Access Compliance Report

Public Rights-of-Way

Intersection ID: 14429	Main Street: LEAKE_ST	Cross Street: WEST_BV	Location: NW
ADA ID: 003AF1F5CA8F	Ramp Type: PerpDiag	Initial Pass/Fail: Fail	Overall Compliance: No
Severity Score: 13.75			
Codes/Mitigation Info/Possible Solution		Field Measurements/Component Compliance

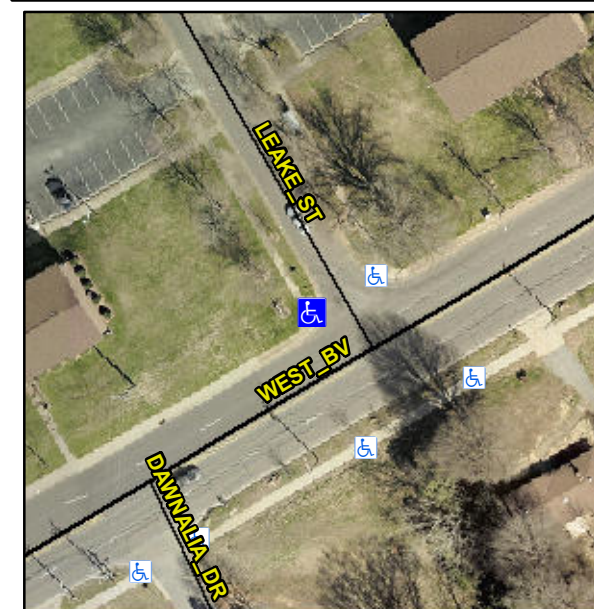
R304.2.2, R304.5.3

Compliance	Description	Data	Compliance	Description	Data
N/A	Ramp Length (in)	55.0	No	Ramp Slope (%)	9.7
Yes	Ramp Width (in)	48.0	No	Ramp XSlope (%)	2.2
N/A	Flare Type LT	N/A	N/A	Flare Type RT	N/A
N/A	Flare Slope LT (%)	N/A	N/A	Flare Slope RT (%)	N/A
N/A	Flare Traversable LT?	N/A	N/A	Flare Traversable RT?	N/A
N/A	Landing Length (in)	N/A	N/A	DWS Provided?	N/A
N/A	Landing Width (in)	N/A	N/A	DWS Contrast?	N/A
N/A	Landing Slope (%)	N/A	N/A	DWS Length (in)	N/A
N/A	Landing X Slope (%)	N/A	N/A	DWS Full Width?	N/A
N/A	Landing Curb? (Y/N)	N/A	N/A	DWS Offset (in)	N/A
N/A	Shared Landing?	N/A			
N/A	Gutter Ponding?	N/A	N/A	Gutter Slope (%)	N/A
N/A	Gutter Lip Ht (in)	N/A	N/A	Gutter X Slope (%)	N/A
N/A	Painted X Walk1?	No	N/A	Painted X Walk2?	No
	X Walk 1 Direction	To S		X Walk 2 Direction	To E
N/A	X Walk 1 Width (in)	N/A	N/A	X Walk 2 Width (in)	N/A
	X Walk 1 Slope (%)	2.4		X Walk 2 Slope (%)	3.9
	X Walk 1 X Slope (%)	2.6		X Walk 2 X Slope (%)	0.2

Remove & Replace Curb Ramp With Two New Directional Ramps or Equivalent.
